WOODSPRING SUITES AT STATION 60 **SITE PLAN?**
PART OF THE SOUTHEAST QUARTER OF SECTION 32
TOWNSHIP 3 SOUTH, RANGE 66 WEST OF THE 6TH P.M.
CITY OF AURORA, ADAMS COUNTY, COLORADO

1st Review
Aurora Water
Jenny Wynn
jwynn@auroragov.org

SITE DEVELOPMENT PLAN
WOODSPRING SUITES AT STATION 60
COVER SHEET

VICINITY MAP

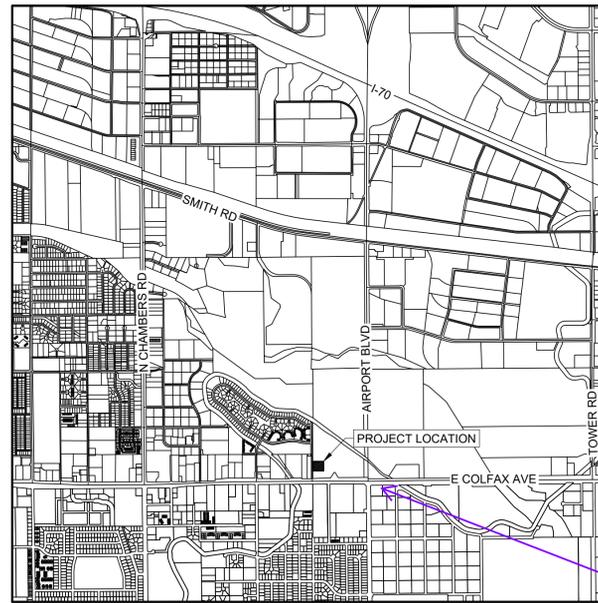
Please scale vicinity map to more clearly show the project location. The map should be centered on the intersection of Colfax Ave. and Airport Blvd. for proper context. Smith Rd. (or thereabout) should be the north most boundary shown.

Vicinity map has been adjusted per comments.

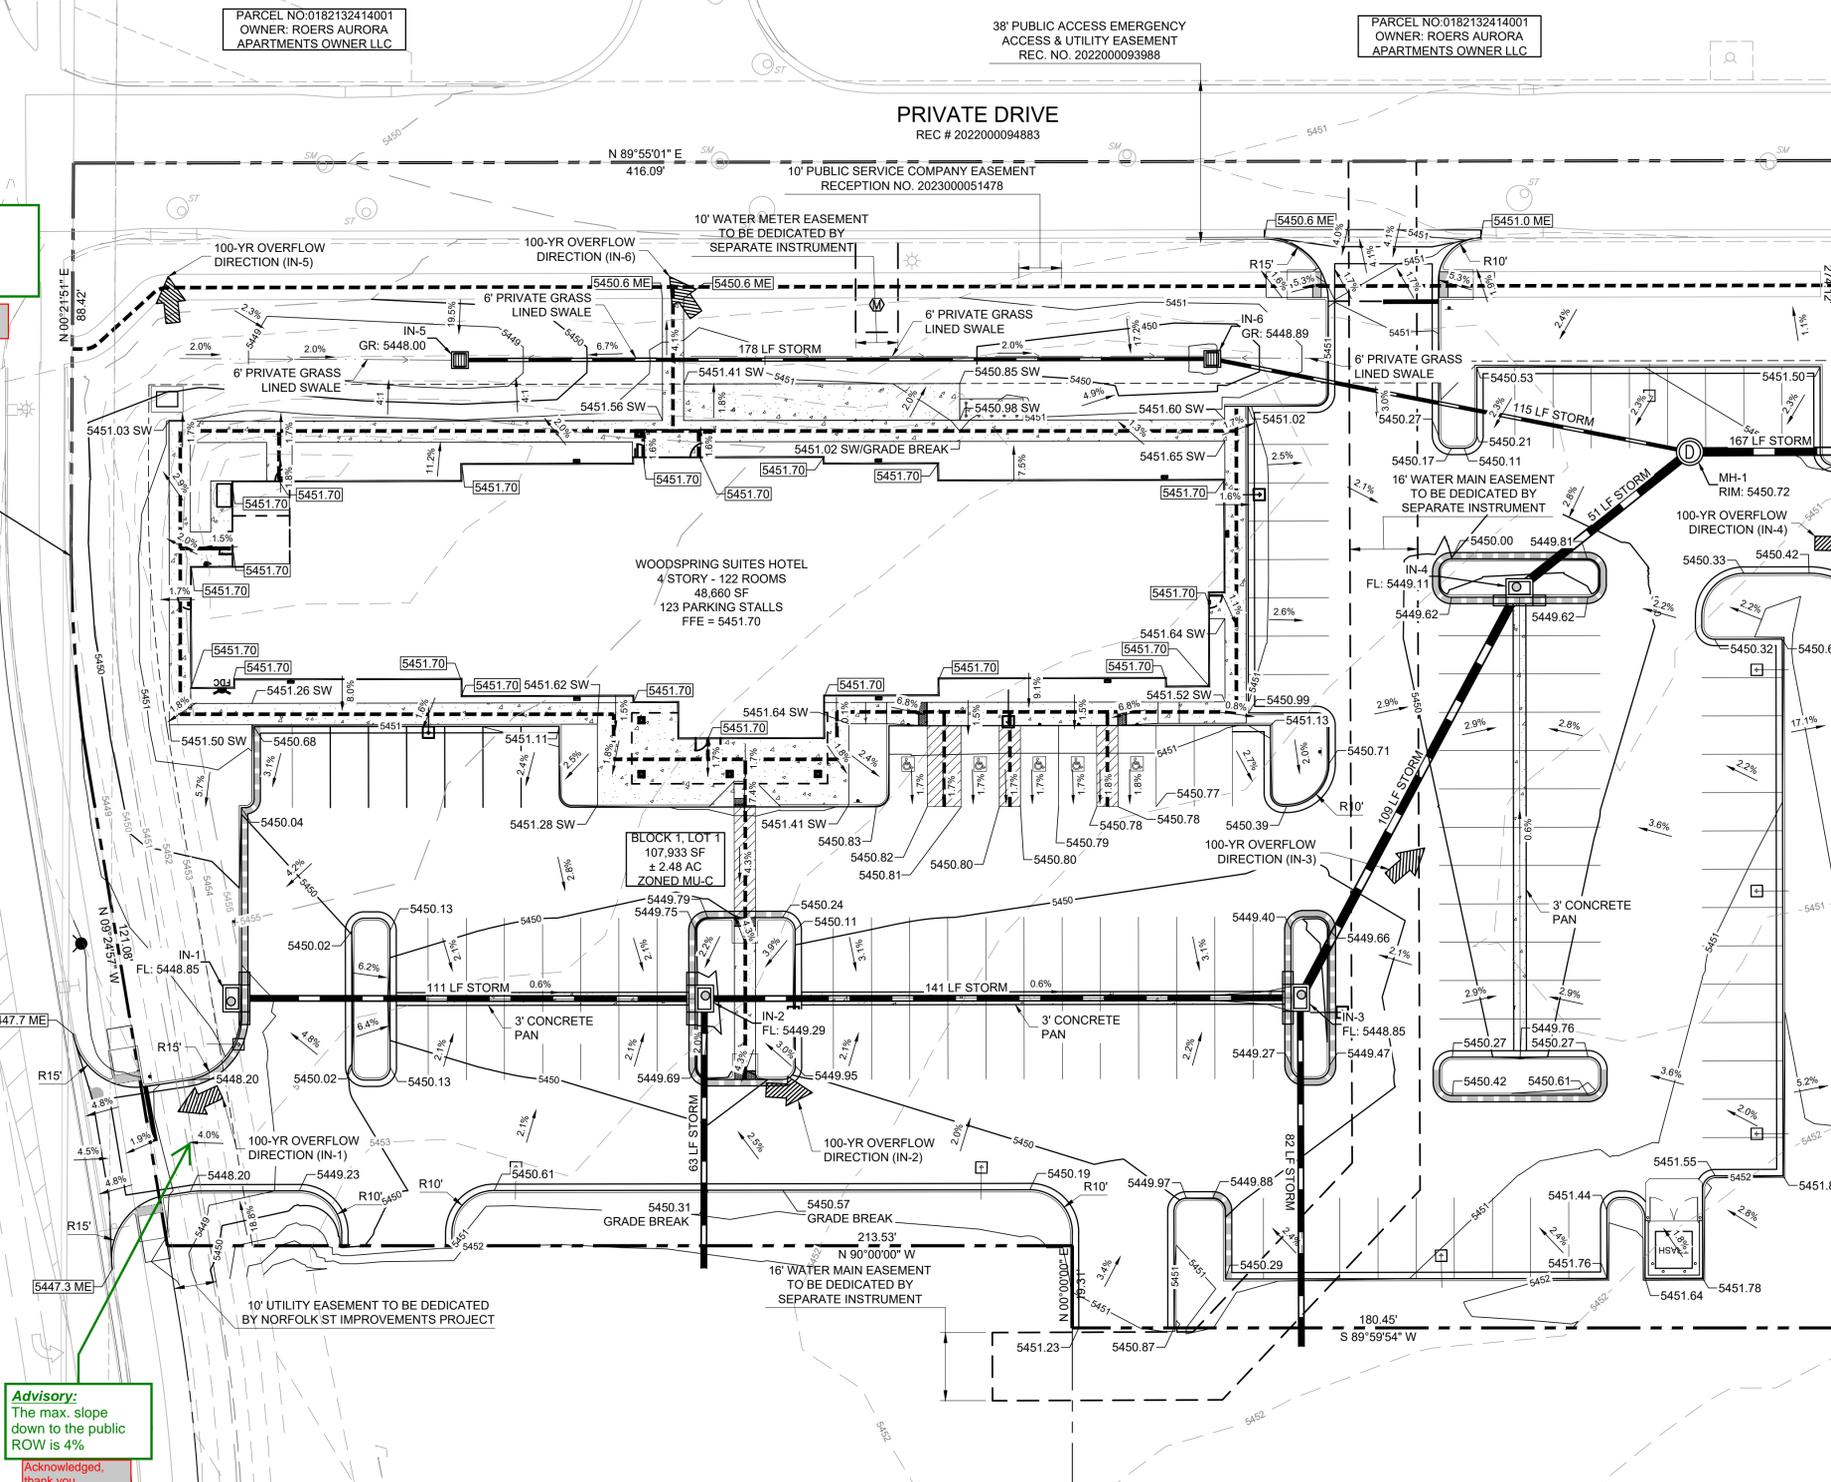
Provide grading notes

Provide/define pavement material type.

Place a note on the Construction Site Plan or Grading Plan indicating all construction vehicles (including construction workers' vehicles) shall access the site from designated truck routes, via Norfolk Street and not through the adjacent residential neighborhood(s).

Please remove all spot elevations. Spot elevations will be require at the Civil Plan process.

Advisory:
The max. slope down to the public ROW is 4%

Notes have been added

All pavement on-site will be asphalt unless called out on plans. See general note 5

Note has been added to General note 4.

All spot elevations have been removed.

Acknowledged, thank you.

1 LANDSCAPE PLAN

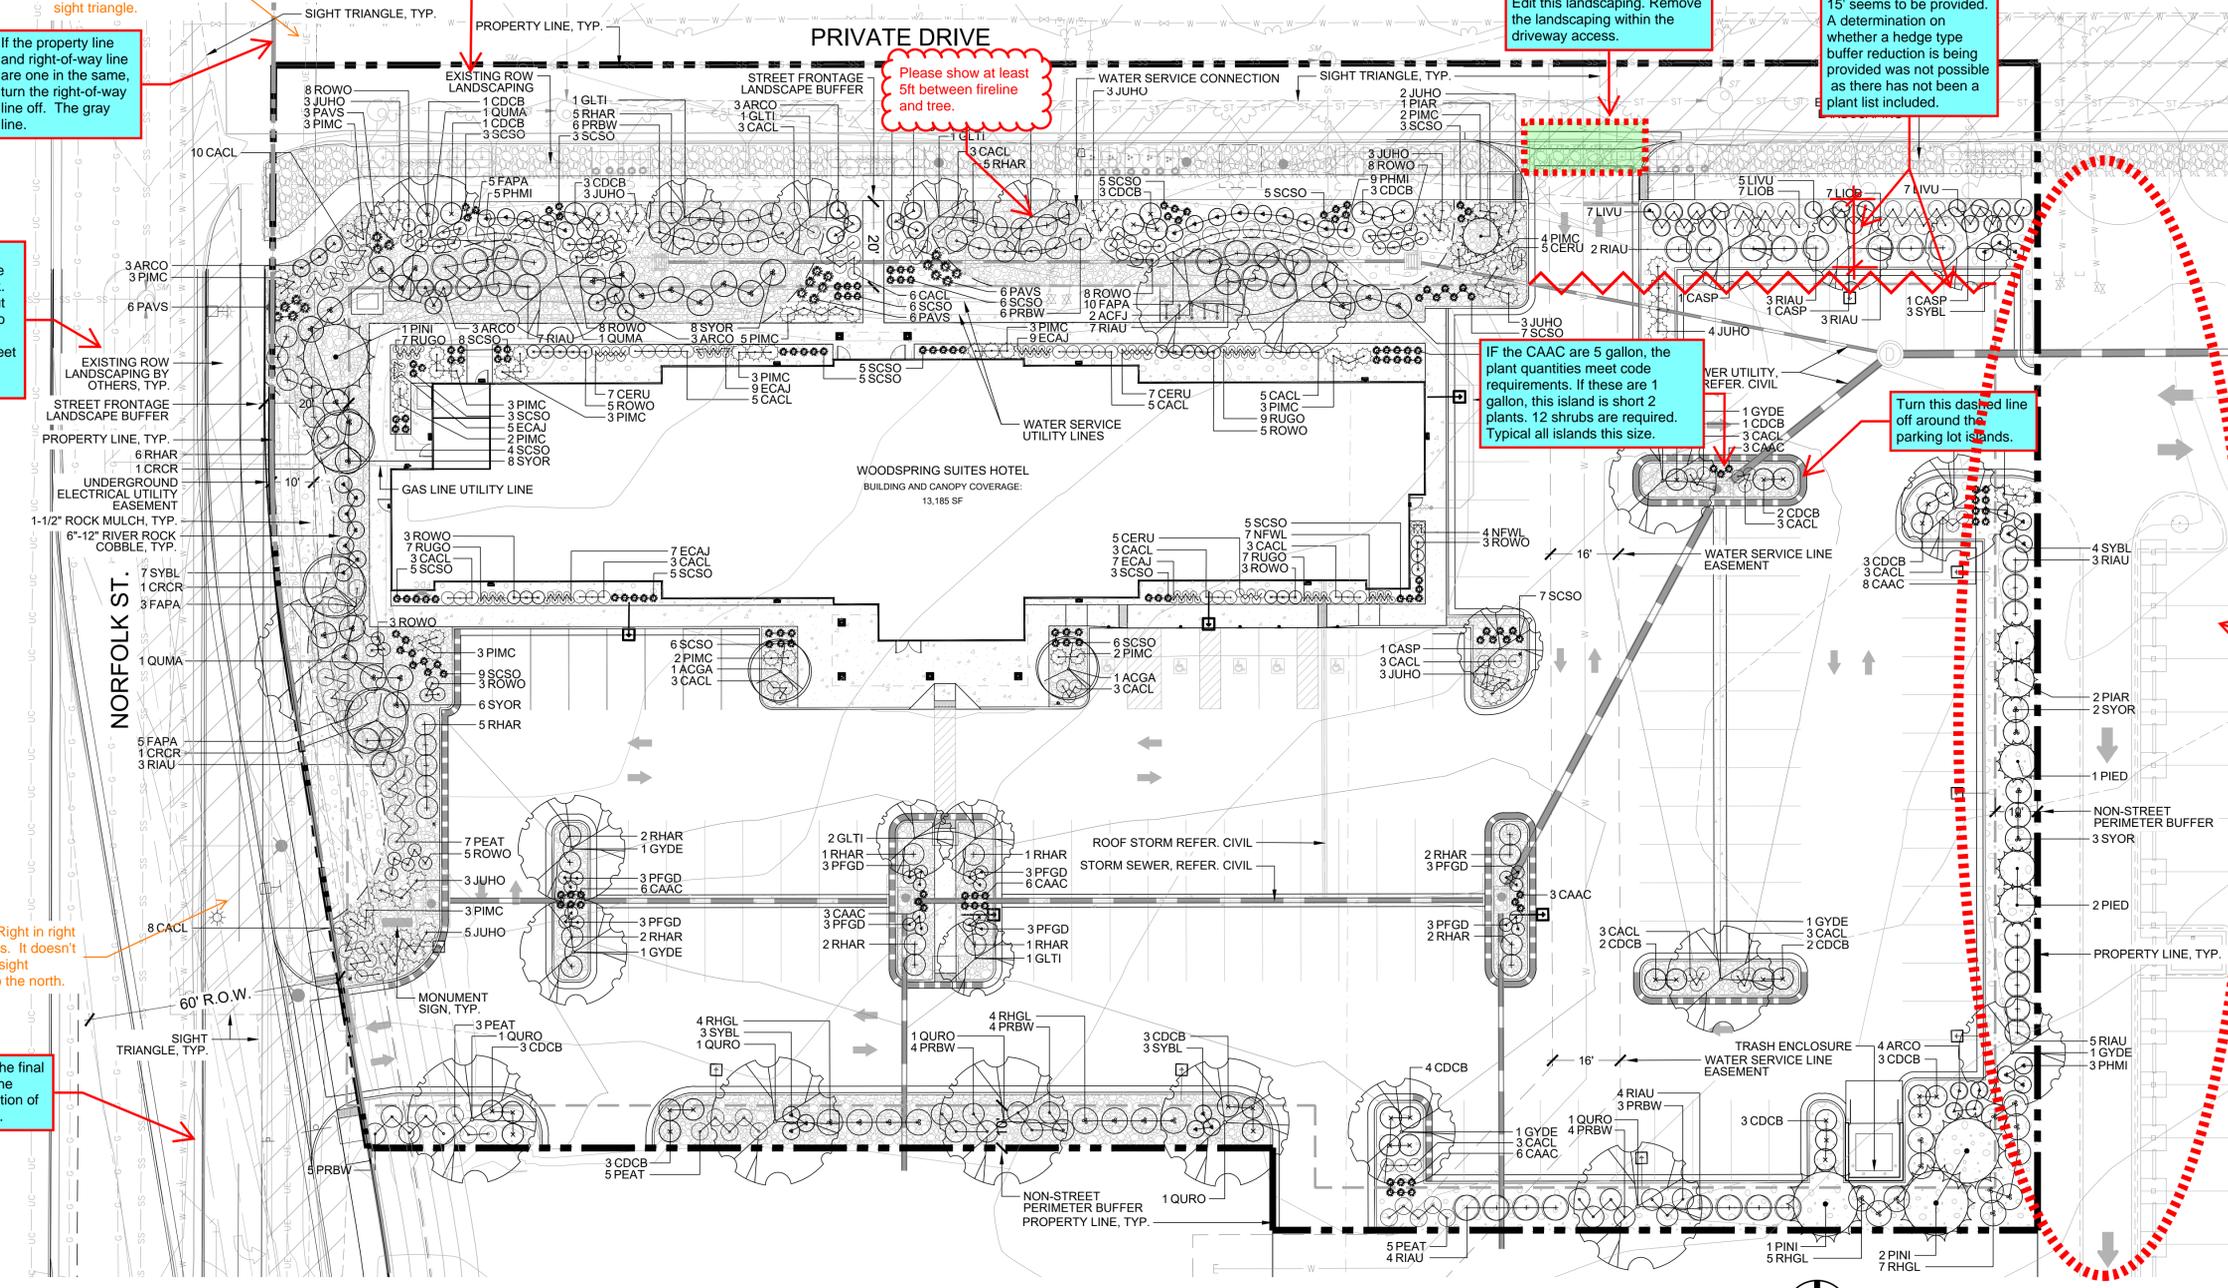
A complete review was not possible as there was no plant list provided. Please provide a plant list with common and botanical names, plant symbols, quantities, sizes etc. so that a complete landscape plan review can be provided.

Need to know the height of the different plants. No plants 7' tall shall be within 50' of a stop sign.

Update this existing call out: Refer to Station 60 ISP Amendment & Street Vacation. CN#2021-6057-01

Need to add a sight triangle for this intersection to verify what plants are in the sight triangle.

Include the landscaping for the street grayed back. Update this call out as follows: Refer to Station 60 ISP Amendment & Street Vacation. CN#2021-6057-01

Please show at least 5ft between fireline and tree.

Edit this landscaping. Remove the landscaping within the driveway access.

Remeasure the buffer along the parking stalls. Parking is not permitted in the street frontage buffer, however a reduction in buffer depth is permitted. 15' seems to be provided. A determination on whether a hedge type buffer reduction is being provided was not possible as there has not been a plant list included.

IF the CAAC are 5 gallon, the plant quantities meet code requirements. If these are 1 gallon, this island is short 2 plants. 12 shrubs are required. Typical all islands this size.

Turn this dashed line off around the parking lot islands.

What is happening here? Is this another private drive? If so, add it to the street buffer table, show the sidewalk and curbside landscaping for the west side.

Show the location of fire hydrants on the Landscape Plan and add to the Legend.

Non-street buffers are not required, however screening of the parking lot/areas are.

01 SITE PLAN - PHOTOMETRIC
SCALE: 1"=20'-0"

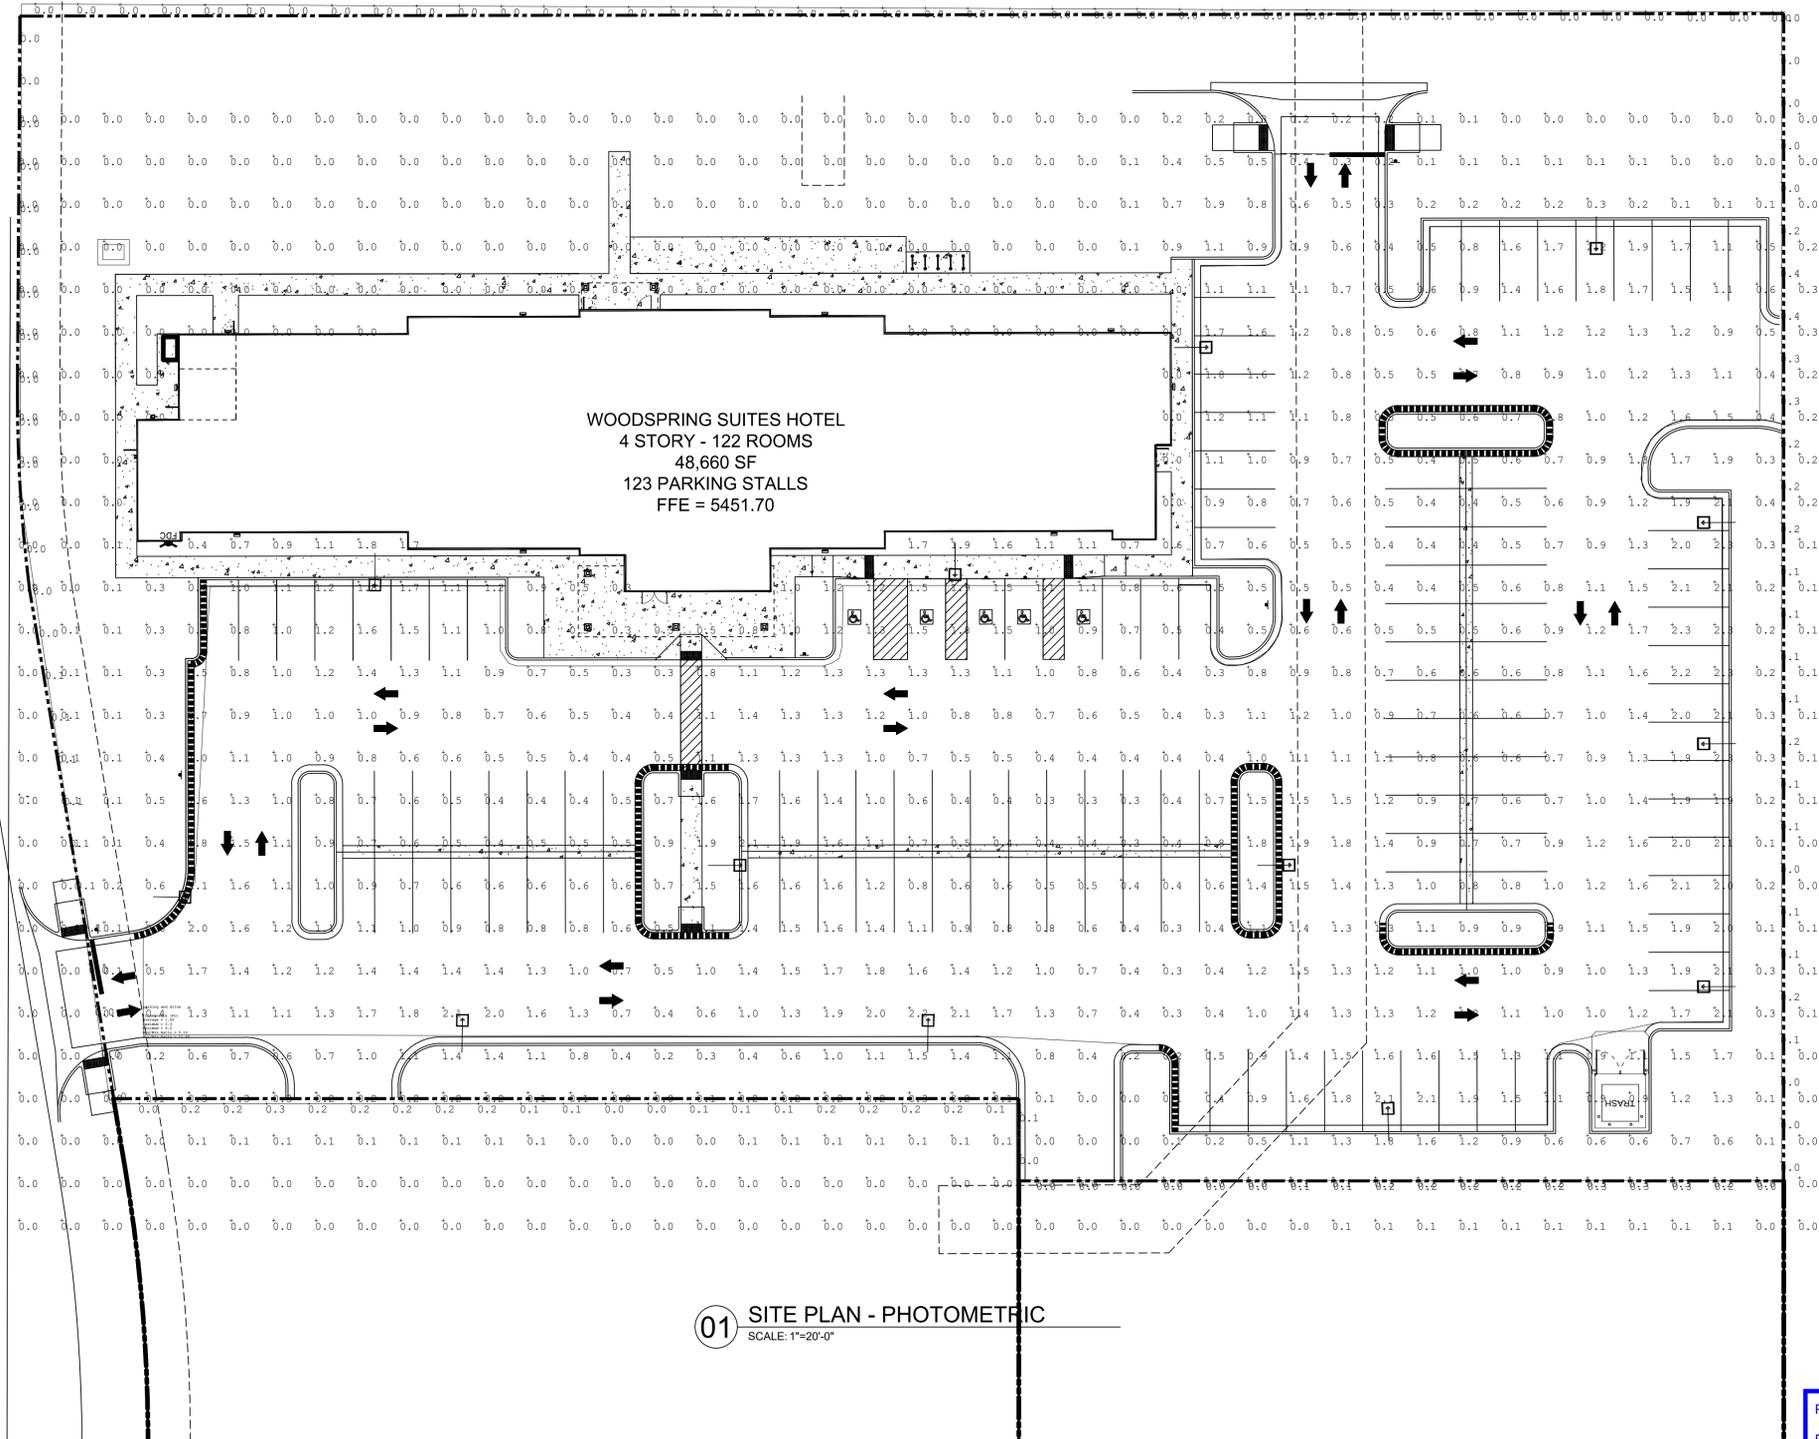
Please add the following photometry plan general notes or notes missing from the notes provided.

Notes have been added
